SERVICE INFORMATION

STANDARDIZATION OF PROPELLER SHAFTS/BOLT PATTERN ON ROTAX 912

4 KUL 94

REVISION 1 MARCH 1995

SKETCH 1

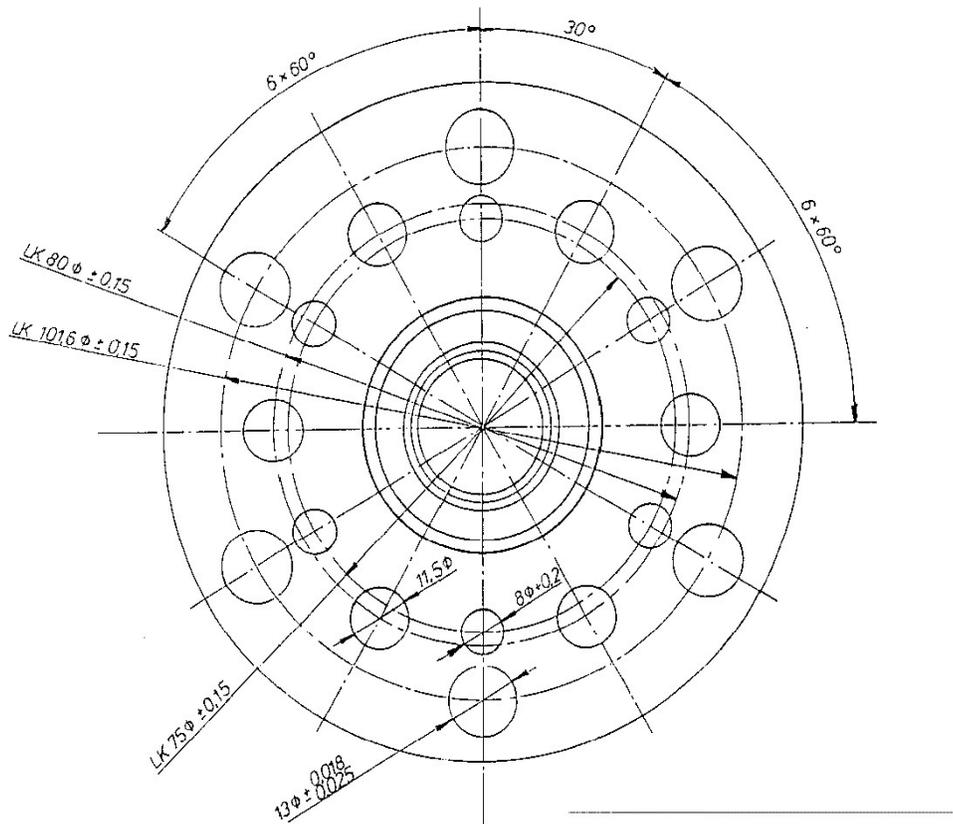
The following information details changes in prop shafts used on the ROTAX 912. Special attention should be given to the changes which have affected prop hub bolt pattern and centering collar (see sketch 1 page 4).

- a) Version 2 (UL, A, F) will be supplied in future, scheduled for production from Sept. 94 onwards
- starting with engine no. 4.153.100 on 912 UL DCDI, model 94
 - starting with engine no. 4.380.600 on 912 A DCDI, model 95
- with the standard propeller shaft 837 285. The prop flange is furnished with 3 pitch circles (see sketch 1).

P.C.D. 75 mm ± 0.15 mm, 6 holes 8 mm dia + 0.2 mm, equi-spaced

P.C.D. 80 mm ± 0.15 mm, 6 holes 11.5 dia. equi-spaced.

P.C.D. 101.6 mm ± 0.15 mm (4"), 6 holes 13 mm dia + 0.018 mm/-0.025 mm, equi-spaced.

- hub diameter (prop centering) 47 mm - 0.5 mm instead of 34.9 mm - 0.05 mm
- height of prop centering 8.5 mm instead of 8.0 mm
- thickness of prop flange 10 mm instead of 8 mm up to now.

The propeller shaft 837 285 on version 2 and prop shaft 837 282 on version 3 and prop shaft 837 287 on version 4 is planned as substitute for all prop shaft fitted previously at production start in September 94 with engine no. 4.153.100 for 912 UL DCDI, model 94, and with engine no. 4.380.600 for 912 A DCDI, model 95. All these propeller shafts will now be supplied with the standardized hole pattern as per sketch 1.

The propeller shaft is furnished with 3 pitch circles.

P.C.D. 75 mm ± 0.15 mm, 6 holes 8 mm dia + 0.2 mm, equi-spaced

P.C.D. 80 mm ± 0.15 mm, 6 holes 11.5 dia. equi-spaced.

P.C.D. 101.6 mm ± 0.15 mm (4"), 6 holes 13 mm dia + 0.018 mm/-0.025 mm, equi-spaced.

- hub diameter (prop centering) 47 mm - 0.5 mm instead of 34.9 mm - 0.05 mm
- height of prop centering 8.5 nun instead of mm
- thickness of prop flange 10 mm instead of 8 mm up to now.

SKETCH 2

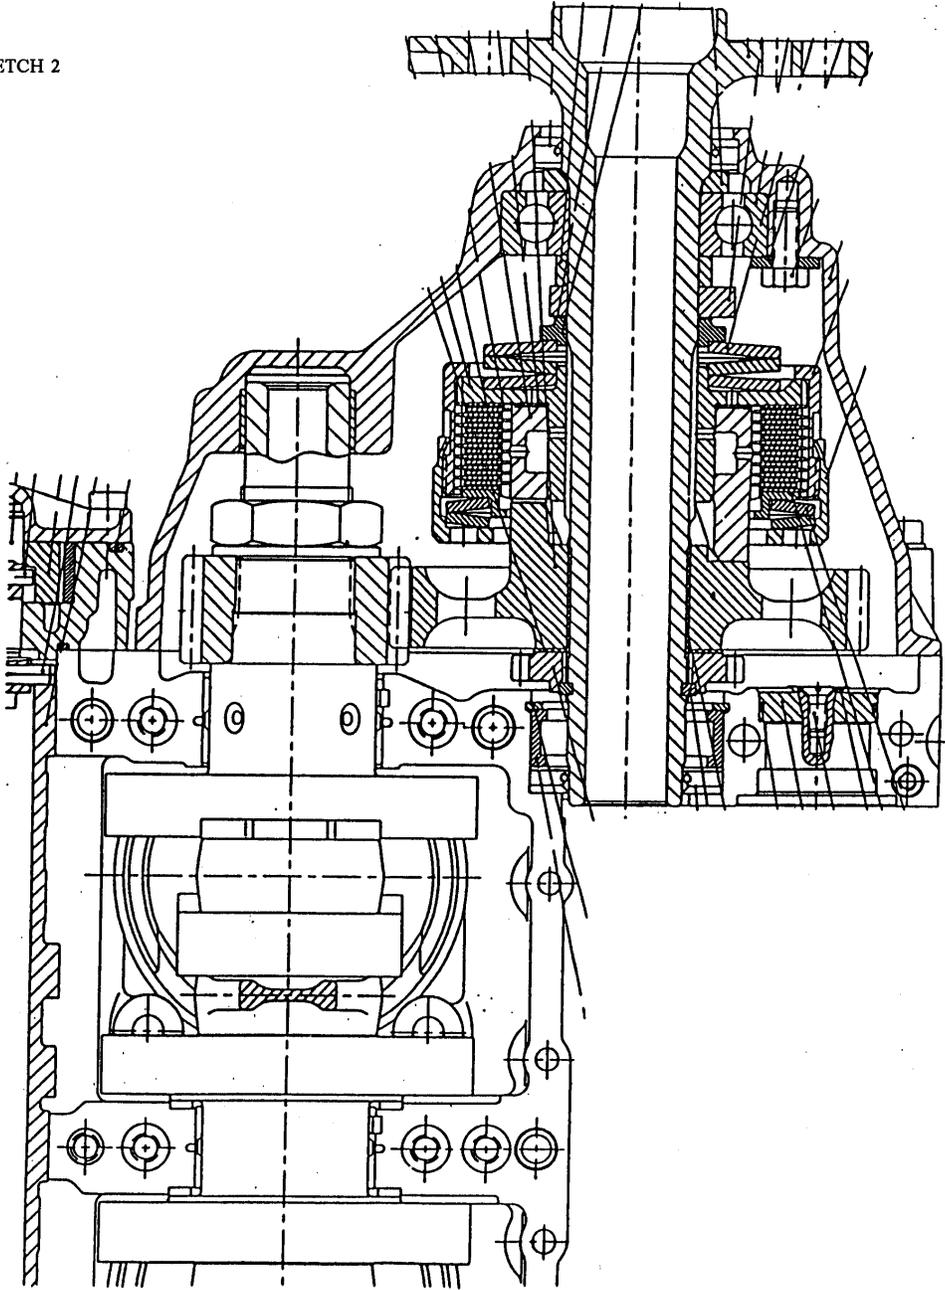
The designation "2" refers to design of propeller shaft 837 285, similar to enclosed sketch 2, showing sectional view of gearbox on engine 912 F2 DCDI with overload clutch, available as an option on 912 UL 2 DCDI.

SKETCH 4

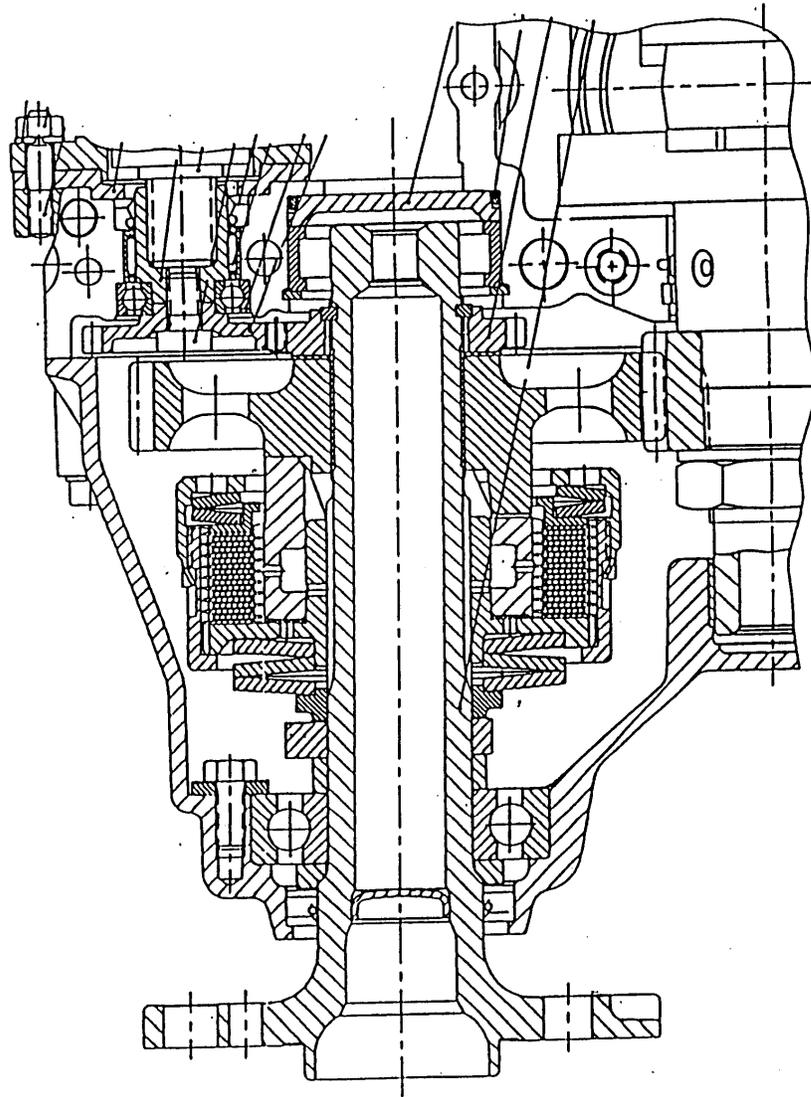
The designation "4" refers to prop shaft 837 287 which is the same as prop shaft 837 282 expect for the plug 244 980 preventing engine oil from escaping. Gearbox housing in engine side is closed too, by cover 810 305. Sketch 4 shows engine 912 F4 DCDI with overload clutch which is also available as an option for the 912 UL 4 DCDI.

The prop shaft 837 287 is the same as in version 3 but plugged with plug cover 244 980. This version can be used for operation with vacuum pump, type Airborne 211 CC, 886 330, by additional installation of vacuum drive set or with Woodward hydraulic governor 886 730 by subsequent removal of plug in prop shaft and fitting with governor and specific components.

SKETCH 5
CROSS SECTION ROTAX 912 A2

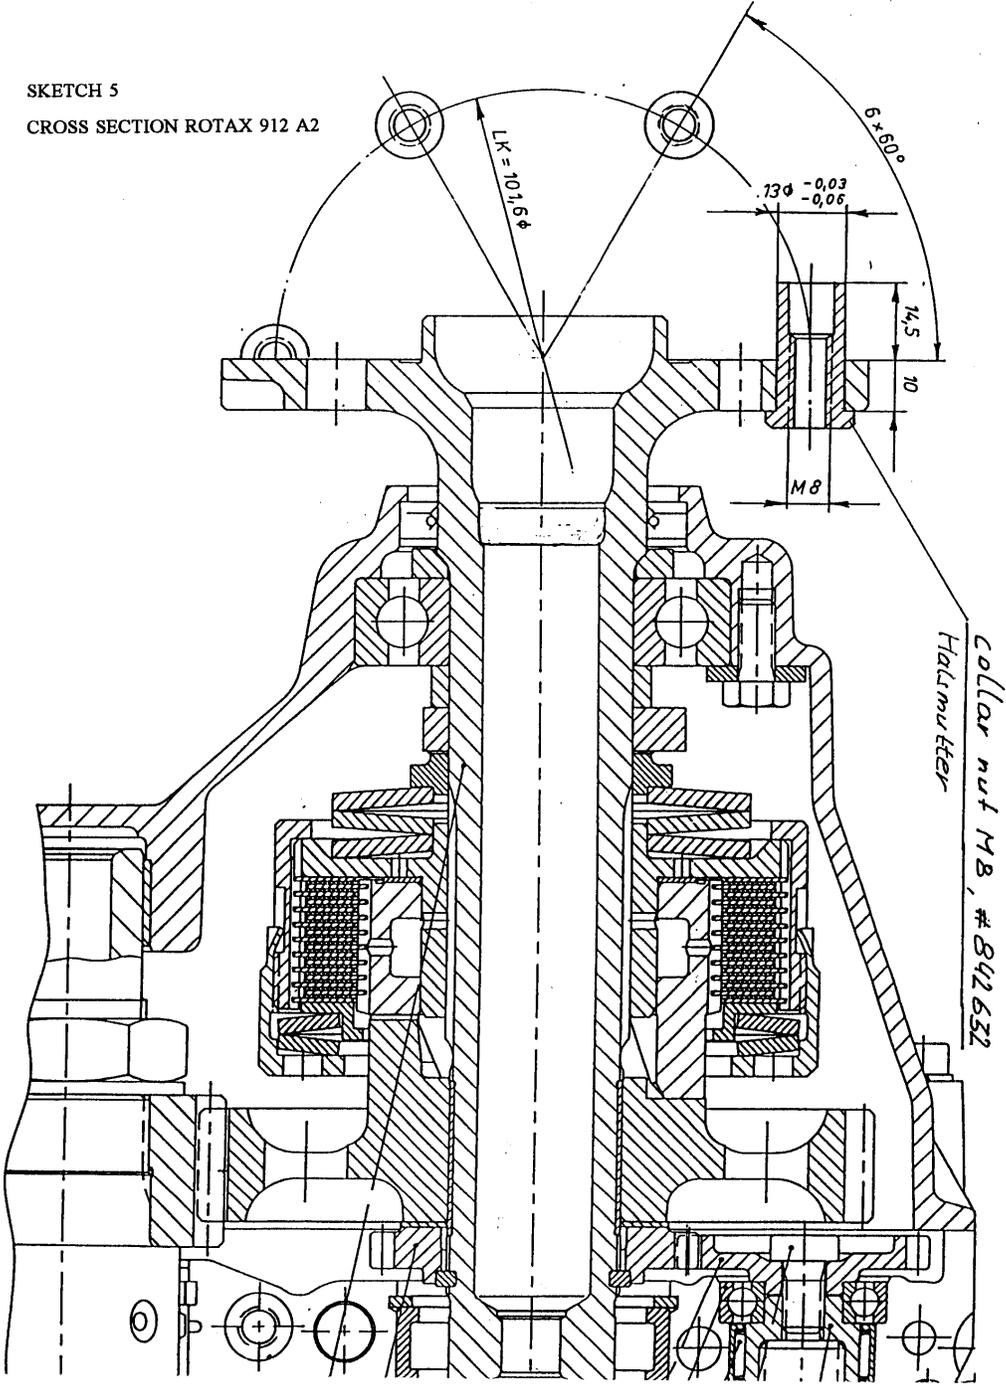
The collar nuts are planned to be pressed into propeller flange holes 13 mm dia. +0.018 mm/-0.025 mm, on P.C.D. 101.6 mm ± 0.15 mm (4") (see sketch 5 and 6).
